SERVICE BULLETIN SB-78A

SUBJECT: Main Rotor Droop Stops and Teeter Stops

ROTORCRAFT AFFECTED: R22 helicopters S/N 0002 thru 2519.

**DROOP STOPS AND BRACKETS**

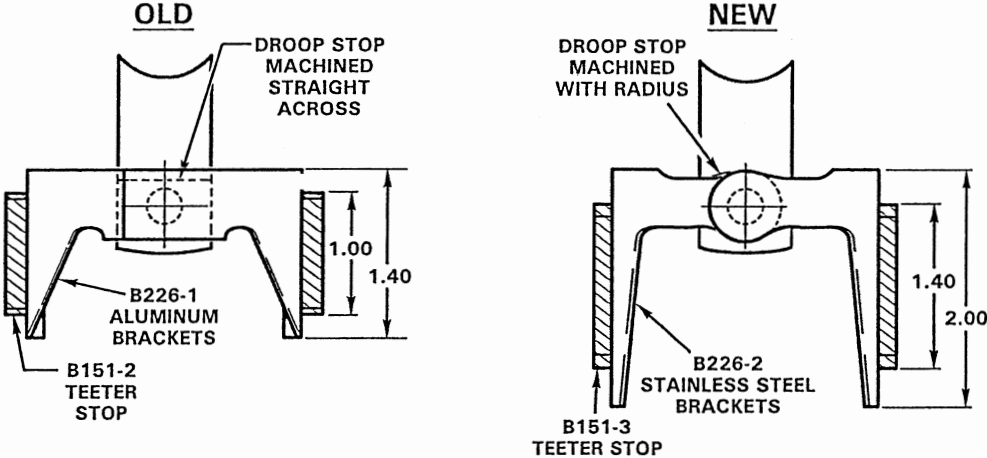
BACKGROUND: Investigation following a recent accident revealed that both main rotor teeter stop brackets had failed. The accident aircraft had not complied with Service Bulletin SB-78 issued in April 1995 which requires installation of strengthened teeter stop brackets. Failure of the brackets could allow excessive teetering of the main rotor.

Determine if SB-78 was complied with. See sketches on page 2 to identify older and newer parts. If SB-78 was not complied with, proceed with SB-78 reprinted below.

1. For each R22 to be modified, reference aircraft serial number and order the following:
  - 2 each A150-1 Rev F or later droop stop
  - 2 each B151-3 teeter stop
  - 2 each B226-2 bracket
  - 2 each NAS1149F0516P washer
2. Cone blades up until spindle tusks move off droop stops and support blades near outboard ends on padded surface or with rope.
3. Note location of droop stops, teeter stop brackets, and hardware. Remove NAS1305-46 bolt.
4. Replace droop stops, teeter stops, teeter stop brackets, and washers with parts procured in step 1.
5. Reinstall NAS1305-46 bolt and torque nut to 240 in.-lb (includes nut self-locking torque). Torque palnut to 40 in.-lb and apply torque stripe.
6. Gently lower blades back onto droop stops.
